# DEVELOPMENT REVIEW COMMITTEE (DRC) COMMENT REPORT

**PROJECT NAME:** RK Center Hotel (Parcel III)

**CASE NUMBER:** PLN-SITE-19120003

**REQUEST:** Site Plan Level II Review: 135 Multi-Family Residential Units, 4,718 Square Feet of Retail, 2,295 Square Foot Restaurant and 10,312 Square Foot Art Studio in Downtown Regional Activity Center

Existing Stormwater Asset Map possibly affected by the Proposed Development

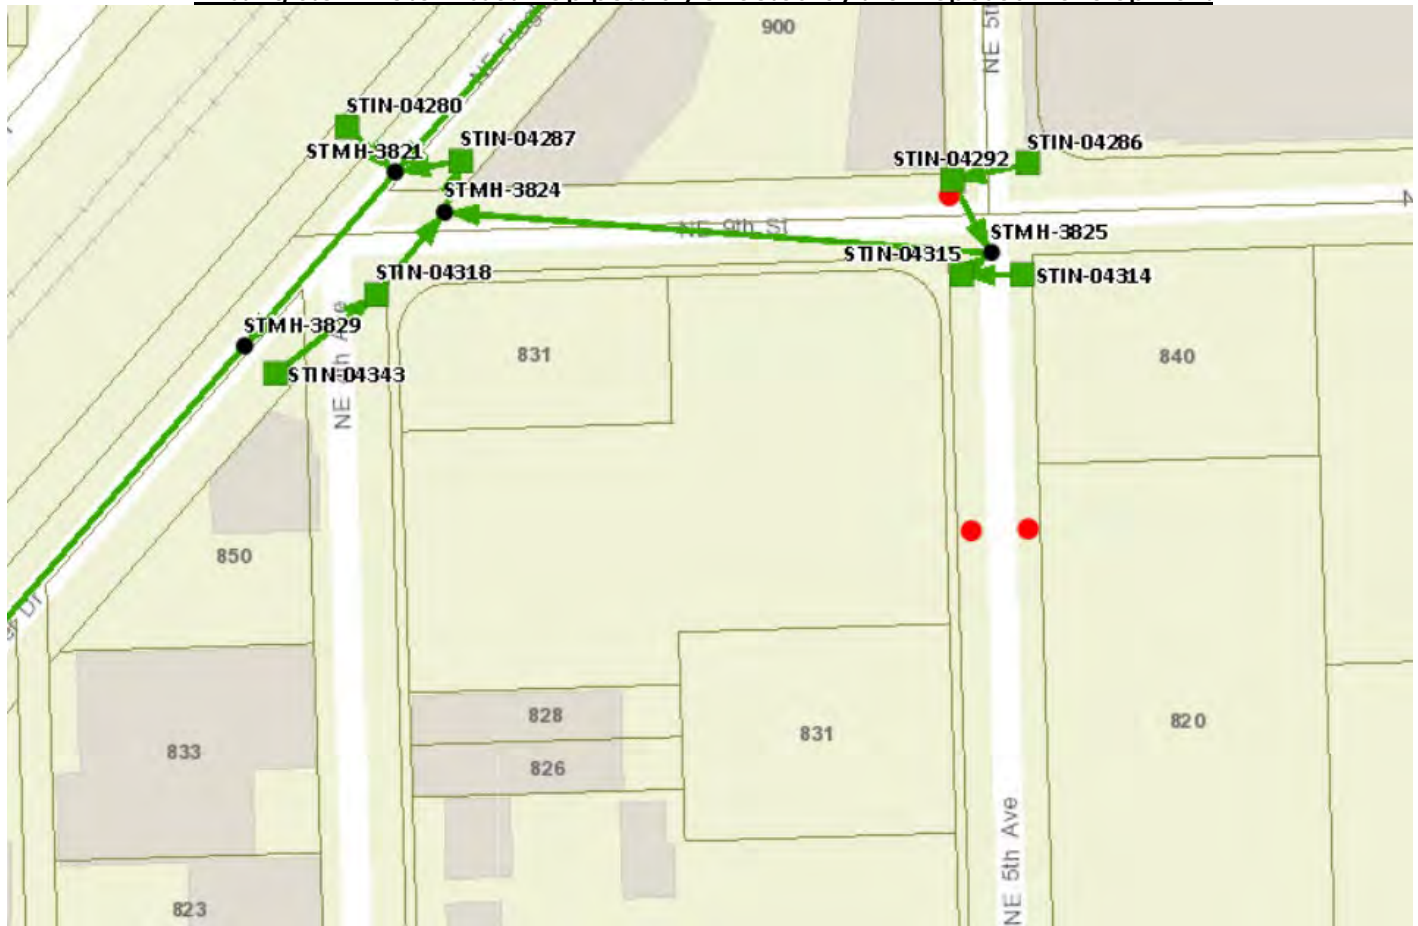
- a. Provide sufficient existing and proposed grades and information on conceptual Paving, Grading, and Drainage Plan and details to demonstrate how stormwater runoff will remain onsite (include typical cross-sections along all property lines as appropriate, typical lot grading for the proposed single family homes within the development, and depict how the new stormwater system will connect to the existing on-site drainage system), and how the proposed project improvements (i.e. on-street parking, sidewalks, etc.) will not adversely impact the adjacent Right-of-Way, properties and waterways. Show location of building roof drains, and their proposed connection(s) to the on-site drainage system. Label existing City storm manholes/inlets using the labels provided in the figure at the end of these notes.

- b. Drainage mitigation shall be required for any impacts within the adjacent City Right-of-Way such as increased runoff or reduction of existing storage/treatment due to proposed improvements, in accordance with the City of Fort Lauderdale Comprehensive Plan (Ordinance C-15-08), Objective 4.1 under Infrastructure Elements. Engineer of Record (EOR) shall evaluate the adjacent City roadway system capacity and demonstrate that the proposed improvements will not negatively impact the City's existing drainage system and provide recommendations in compliance with the City's Comprehensive Plan (i.e. meets or exceeds the 10-year/1-day storm event drainage criteria). Applicant shall be responsible for maintenance of these proposed storm drain infrastructure improvements located within City Right-of-Way during a 1-year warranty period, until accepted by the City's Public Works
